**SUBJECT: CRYSTAL RIVER NUCLEAR PLANT - SPECIAL INSPECTION REPORT
05000302/2009007**

Report No: 05000302/2009007

Facility: Crystal River Unit 3

Figure 5.2.1 Tendon Pattern at SGR Opening and Delamination Profile

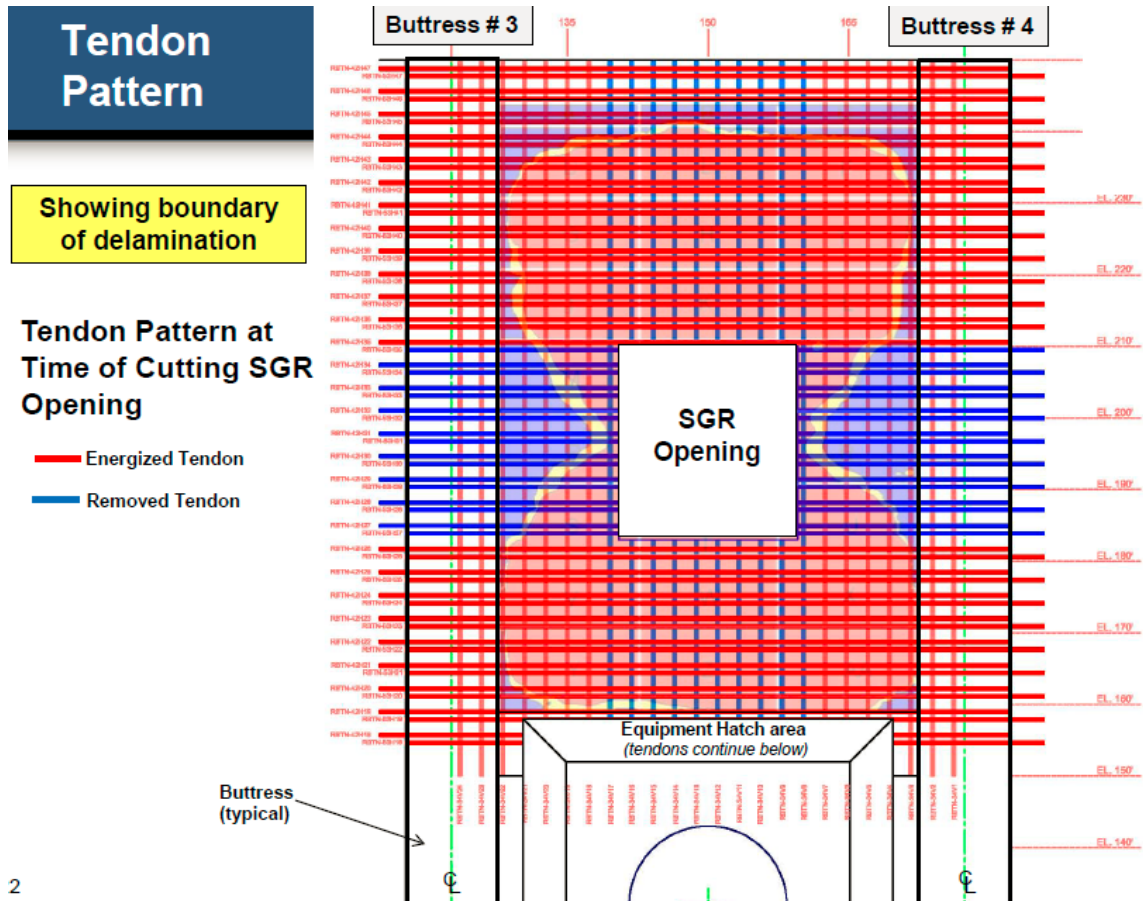
impulse response non-destructive testing technique with confirmatory core boring and boroscopic examinations, determined that the extent of the delamination was limited to Bay 3-4 corresponding to an approximately 60 ft wide by 82 ft high hourglass-shaped area, which included the SGR construction opening, between Buttresses 3 and 4, extending from above the equipment hatch to approximately ten ft below the bottom of the ring girder. The tendon pattern at the SGR opening and the hourglass delaminated boundary is shown in Figure 5.2.1.

Figure 5.2.3 Failure Modes Timeline

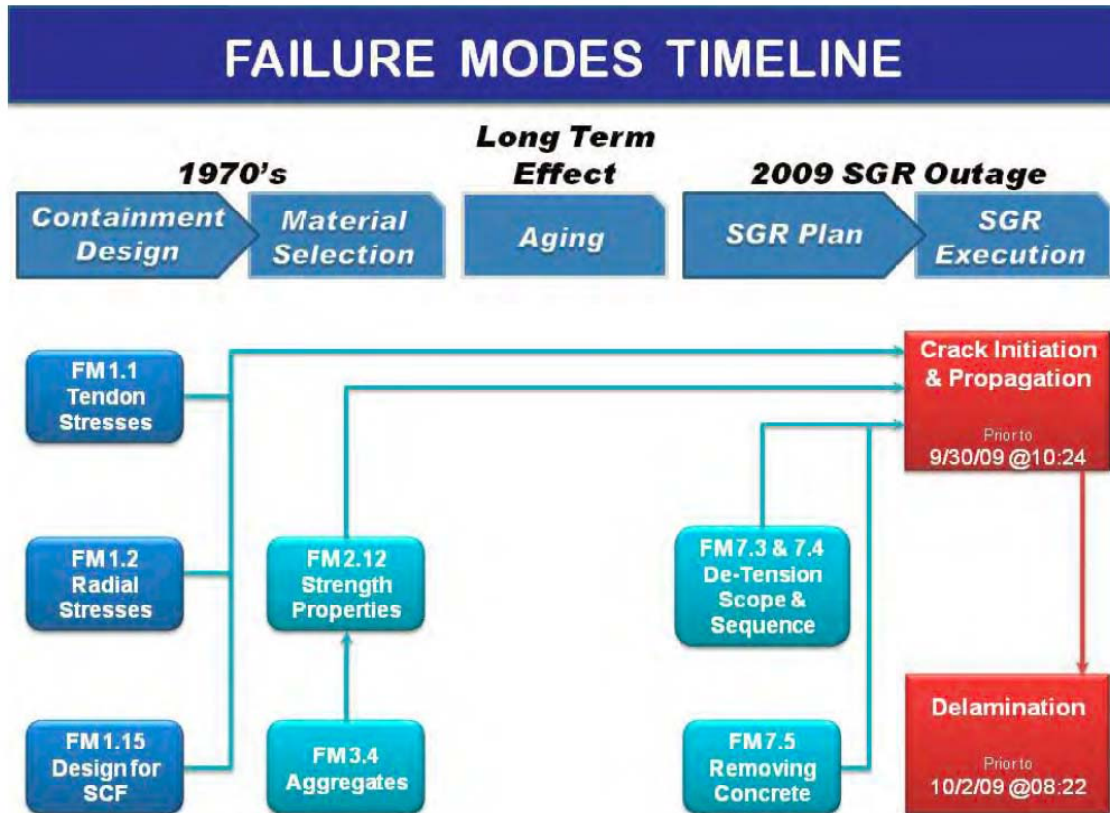
Following the analysis of failure modes, the licensee determined the timing of the contribution of each causal failure mode to the wall delamination event in the Failure Modes Timeline, as shown in Figure 5.2.3. The licensee's root cause analysis and computer simulation determined that the large-scale delamination observed did not exist prior to the SGR opening operations but occurred during construction activities for creation of the SGR construction opening, while the unit was shut down. This determination was supported by the following evidence: (1) the condition assessment confirmed that the delamination was present only in Bay 3-4, the panel where the SGR opening operations were performed, and not in any of the other five bays; (2) the shape of the delaminated area of Bay 3-4 corresponds exactly to the region of detensioned horizontal and vertical tendons (see Figure 5.2.1), indicating that the detensioning process influenced the delamination process, which could not happen if the delamination occurred prior to the detensioning; and (3) traditional petrographic analyses did not detect the presence of pre-existing defects (general lack of significant carbonation and mineral growth on the fracture surface).
